# UNITED STATES PATENT AND TRADEMARK OFFICE

APPLICATION NO.	FILING DATE	FIRST NAMED INVENTOR	ATTORNEY DOCKET NO.	CONFIRMATION NO.
10/674,319	09/29/2003	Gregory C. Lee	LAM2P434	4630

**Office Action Summary**

### **DETAILED ACTION**

**Fig. 3**

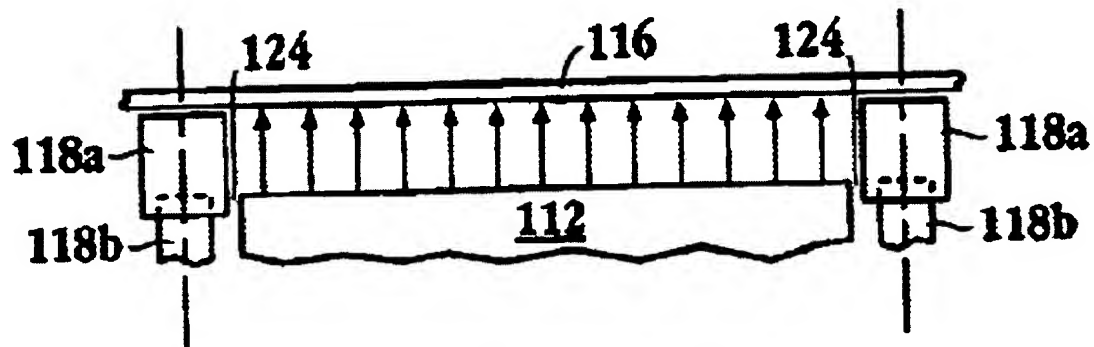
With reference to Figures 3 and 7, Boyd'024 discloses the claimed invention including:

- a. a platen 112 introducing air fluid beneath a polishing pad 116.
- b. a platen support cover 118a configured to surround the platen 112, the platen 112 being disposed at a first level and the platen support cover 118a being disposed at a second level, the first level being lower relative to the second level, the platen 112 and the platen support cover 118a configured to be disposed below a polishing pad 116 such that the polishing pad 116 is closer to the second level than the first level.
- c. at least one fluid output control path 129 defined through the platen support cover 118a, the at least one fluid output control path 129 enabling controlled release of fluid contained over the platen 112, surrounded by the platen support cover 118a, and beneath the polishing pad 116.
